City of Santa Fe, New Mexico

memo

455 ST. MICHAELS DRIVE CHRISTUS ST. VINCENT REGIONAL MEDICAL CENTER.

Case #2015-47. 455 St. Michaels Drive Christus St. Vincent Regional Medical Center. WHR Architects, Inc., agent for Christus St. Vincent Regional Medical Center, request review and approval for:

Attachments: IPSP Detail

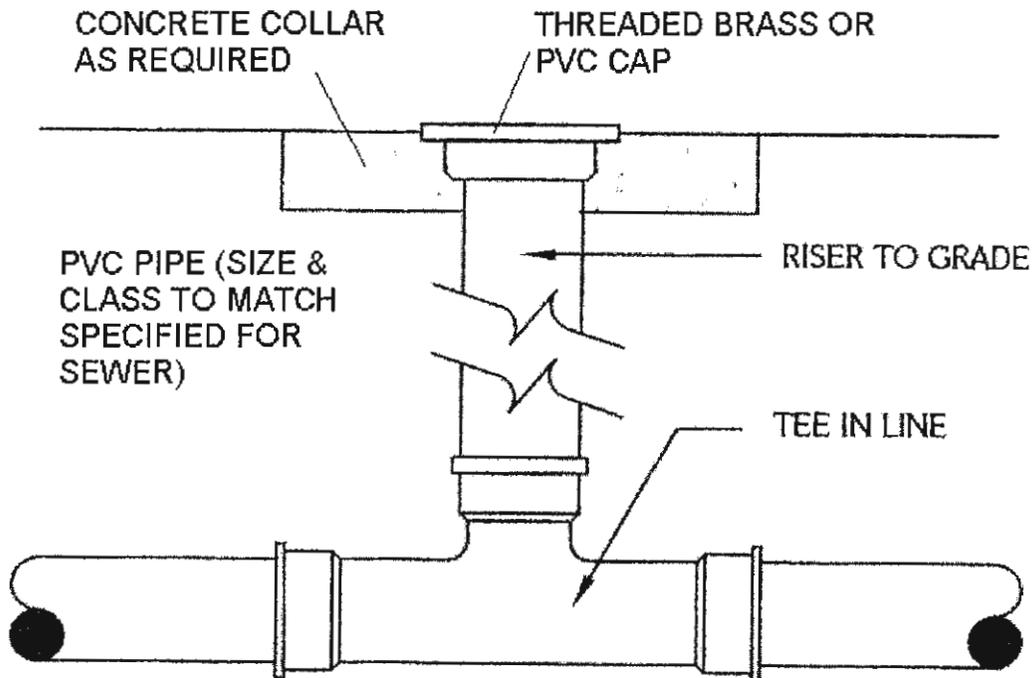
6. Industrial Pre-Treatment Sampling Ports (IPSP) are required and shall be shown on the Utility Plans. See attached detail.
7. Indicate on the drainage plans where the discharge points are located from the Development to help determine if the site discharge will impact the existing public sewer line and access

Each separate building or leased / rented area within a building shall have its own Industrial Pre-treatment Sampling Point ("IPSP"). The IPSP is similar to a cleanout except it has a tee fitting instead of a sweep. Note that sampling at a manhole is no longer allowed. The IPSP is in addition to the cleanouts shown on the plans. The IPSP shall be located in an easily accessible area for possible future sampling. The IPSP must also be located in an unobstructed area that will allow the placement of a 2'x'2'x2' sampler that will need to be in place for a week. The IPSP can be located inside or outside of the building. If the IPSP is located outside the building, it must be in area where there is no vehicular traffic and in area which the sampler will not impede pedestrian traffic. The IPSP must be located where the entire wastewater discharge of the building or leased/ rented area is flowing and where no other outside wastewater flows are introduced. The IPSP must be located downstream of any Industrial Pre-treatment facilities (such as grease trap). If you have any question regarding the Industrial Pre-treatment requirements or question about the sampling point location, call the Industrial Pre-treatment Section at 955-4635 (Raul Martinez). For all other question, please call the Wastewater Management Utility Development Section at 955-4613 (Douglas Flores) or 955-4637 (Stan Holland). **Show the IPSP on the plans.**
